Service Bulletin

No. : MZ07-033 **Date:** May 19, 2008

Subject: "Can't Play" is displayed on LCD.

SA11S1, SA15S1, SA8001

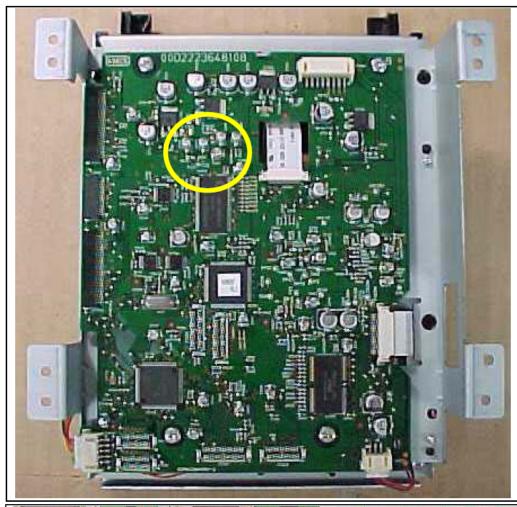
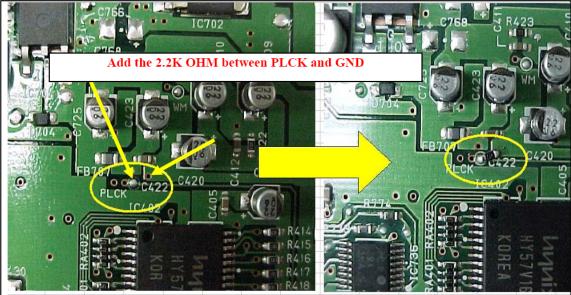
Symptom: During playback a Super Audio CD, "Can't Play" is displayed on LCD.

Solution: Mount 2.2K OHM on the Super Audio CD PWB Module where indicated.

Mount POS.NO. R410 2.2K OHM (PART NO. 00D2472008926) onto the Super Audio CD PWB Module.
